Origination Form
Proposed Revisions to a Standard Plans Index

Originator:	Stepp, Richard	Index Number:	102-110
Date:	10/18/2024	Sheet Number(s):	1,4, 7-10
E-mail:	richard.stepp@dot.state.fl.us	Index Title:	Type K Temporary Concrete Barrier System

TYPE K TEMPORARY CONCRETE BARRIER SYSTEM

INDEX
102-110

CONNECTION TO PERMANENT RIGID BARRIER NOTES:
~~THRIE-BEAM GUARDRAIL SPLICE INSTALLATION NOTES:~~

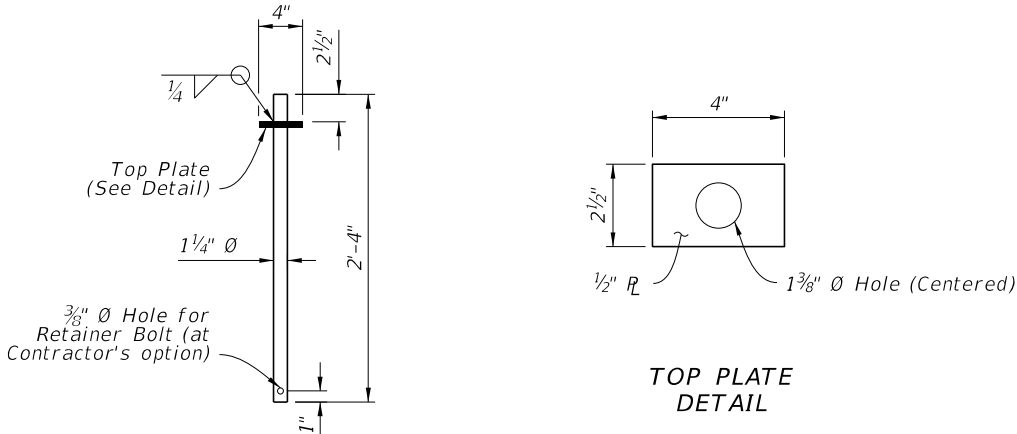
Sheet 1: General Notes - Rename "THRIE-BEAM GUARDRAIL SPLICE INSTALLATION NOTES" to "CONNECTION TO PERMANENT RIGID BARRIER NOTES". Added a new Note 1 to reference sheet numbers with splice connections and define barrier nomenclature. Incremented previous note numbers to account for the new Note 1.

1. For splice connection details between Type K Temporary Concrete Barriers and Permanent Traffic Railings, see Sheets 7 thru 10. Within this Index, the term Traffic Railing also applies to Concrete Barrier, where both terms refer to permanent installations shown in the Index 521 series.

LAST REVISION 11/01/23	DESCRIPTION: 11/01/25	FDOT	FY 2025-26 2026-27 STANDARD PLANS	TYPE K TEMPORARY CONCRETE BARRIER SYSTEM	INDEX 102-110	SHEET 4 of 17
---	--------------------------	------	---	--	------------------	------------------

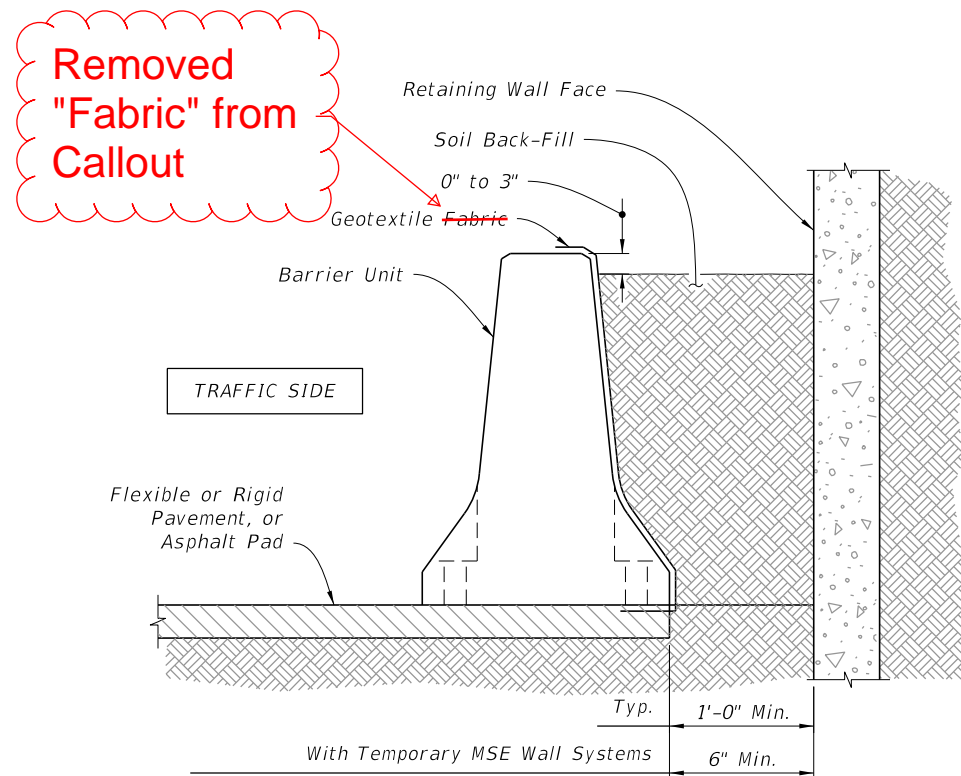
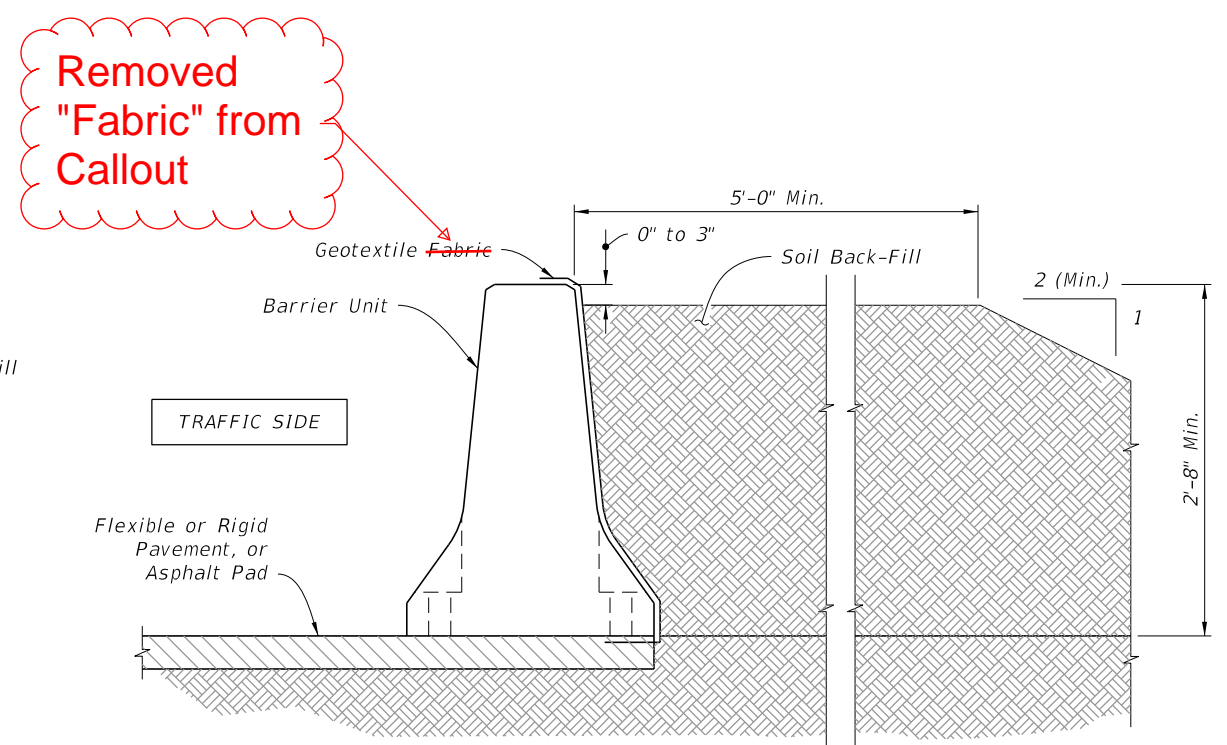
Sheet 4: Deleted "Fabric" from "Geotextile Fabric" callout on Typical Section details

Also, per a revision request from the State Materials Office, the word "fabric" is being removed from "geotextile" callouts.

PARTIAL PLAN VIEW AT MEDIAN TRAFFIC RAILING

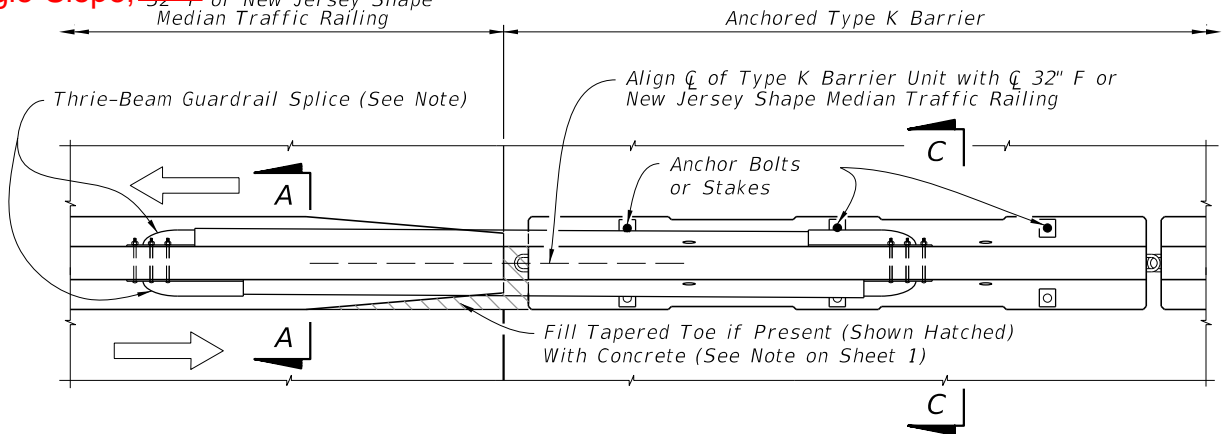
Sheets 7-10: Revised detail labels to simplify and include "Single-Slope" Traffic Railings and Concrete Barriers where applicable.

F-Shape, Single-Slope, ~~32" F~~ or New Jersey Shape Median Traffic Railing
